Access Compliance Report Public Rights-of-Way (Curb Ramps)

Main Street: RED_HILL_AVE Cross Street: CAMEO_DR Location: NW

ADA ID: RPAT211021142232 Ramp Type: Type 3 - Combination 1 Initial Pass/Fail: Fail Overall Compliance: No Severity Score: 15

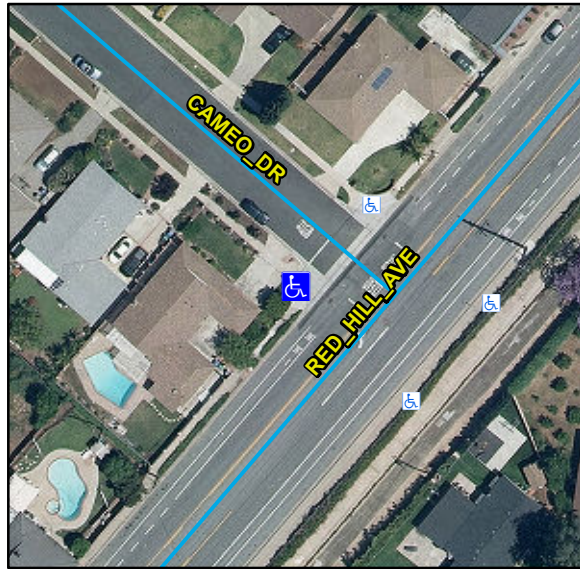
R304.2.2, R304.3.2, STD 1115

Remove & Replace Curb Ramp With Two New Directional Ramps or Equivalent.
